### Changes from Originally Certified Design:

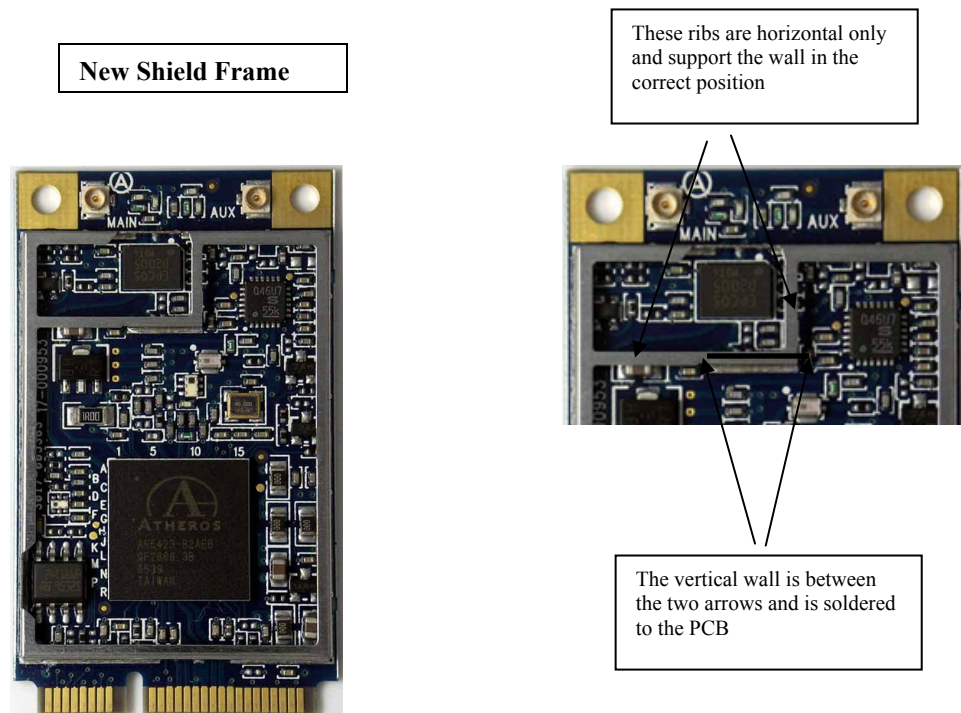
1. Added internal shield wall  
This change provides a grounded wall within the shield cavity between the radio I.C. and the 5GHz receiver input to suppress interference from harmonics of the PCI Express bus signals. The PCB design was changed only to open a window in the solder mask material over the ground plane so that the shield can be soldered to the PCB original ground plane during manufacture.

2. Removed eccosorb material attached to inside of shield cover. This material previously provided some suppression of the PCI-Express bus harmonic. This is no longer need due to shield wall addition (#1 above).
3. Added R159 51ohm resistor in series with C17 at the terminated input of the LNA. This improves receiver sensitivity.
4. Changed some trace routing in the digital circuits (not RF section) for BT\_Active and Rx\_Clear signals.
5. Changed reset circuit RC values to 47kohms (R6) and 0.1uF (C1) located in digital section (not RF).
6. Disabled Turbo Modes (modulations using channel bonding) in hardware. Turbo mode(s) cannot be enabled/disabled using firmware or software.
